Work Order ID 87158

Item Name: Crosstube Turning Detail

DART AEROSPACE LTD	Work Order:	87158
Description: Crosstube Assembly (412 High Aft)	Part Number:	D412-664-243
Inspection Dwg: D412-664-243 Rev: E		Page 1 of 2

DRAWING NO. D412-664-243	TITLE CROSSTUBE ASSEMBLY (412 HI AFT)	REV. E	DART AEROSPACE LTD ENGINEERING ORDER		D.E.O. NO. D412-664-243-E-1	SHEET NO. SHEET 1 OF 2	SCALE NTS
DRAWN	CHECKED	MFG. APPR.	APPROVED	DE APPR.			
DATE 11.03.31	DATE 11/03/31	DATE 11.03.31	DATE 11/03/31	DATE 11-03-31

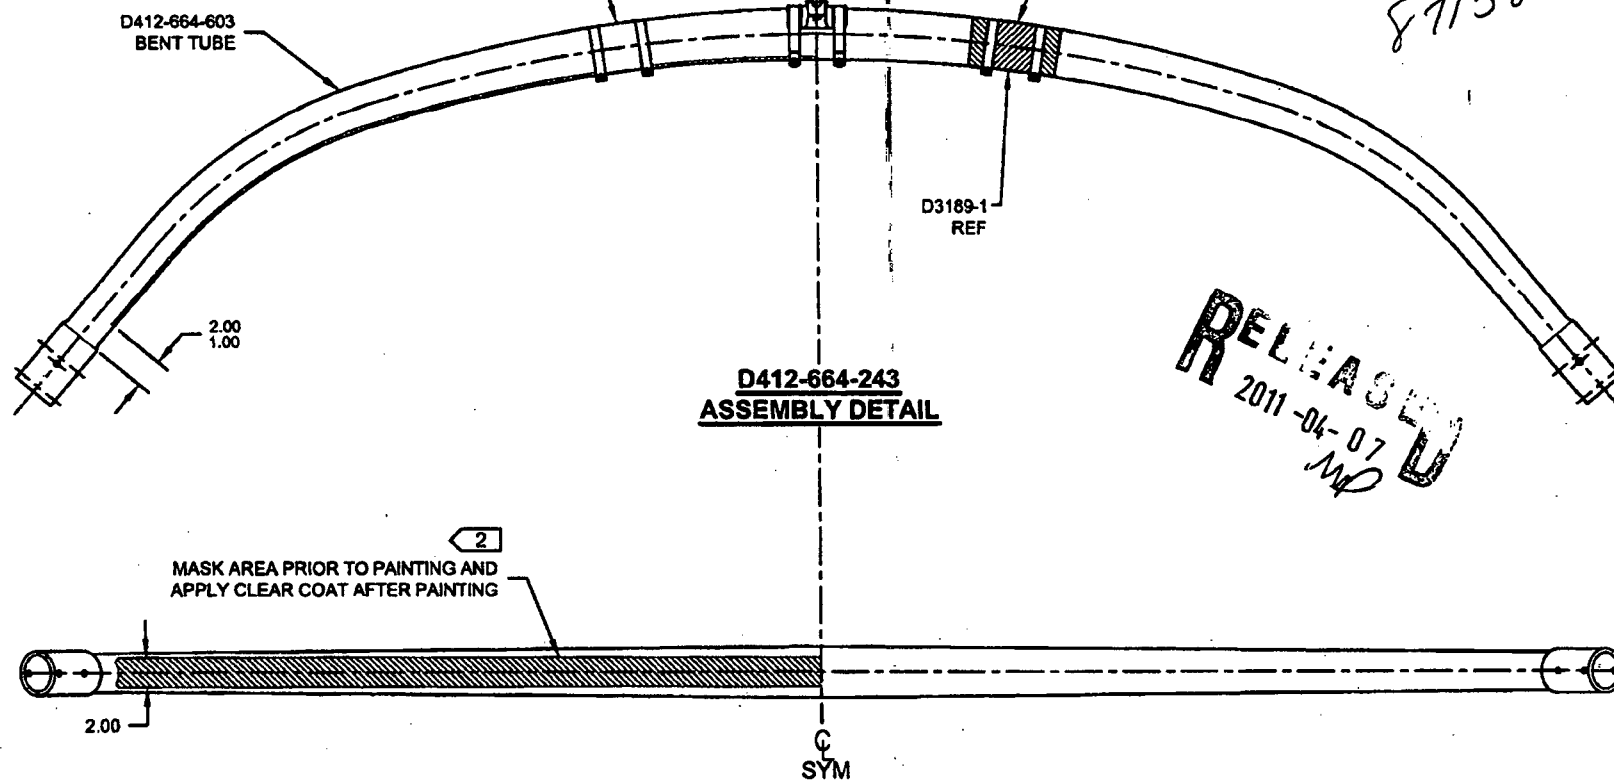
REMOVED ABRASION STRIP IN FAVOR OF A THIN LAYER OF PROSEAL 890.

PARTS LIST IS AMENDED AS FOLLOWS:

NOTES 2 AND 14, SHEET 1 ARE AMENDED AS FOLLOWS:

IS:

D3189-1 CHAFING SHIELD (1, INSTALLED OVER PROSEAL 890)
MS21920-28 CLAMP, 2X
2 PL

WAS:

D2856-600-1009 ABRASION STRIP
D3189-1 CHAFING SHIELD (1, INSTALLED OVER ABRASION STRIP)
MS21920-28 CLAMP, 2X
2 PL
